INDIANA HARBOR BELT RAILROAD COMPANY

BULLETIN ORDER NO. S-26

Effective: 0001 Sunday March 4, 2018

7. IHB Timetable No. 1 Special Instruction 2603, item 3 Track obstructed for maintenance, Working Limits (Line 3) on page 82 is Revised:

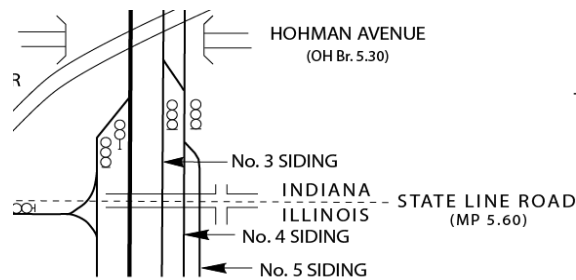
Effective 0600, November 16, 2017, within special instruction 2603 on page 82 employees must strikethrough all bullet points under item 3 Track obstructed for maintenance, Working Limits (Line 3).
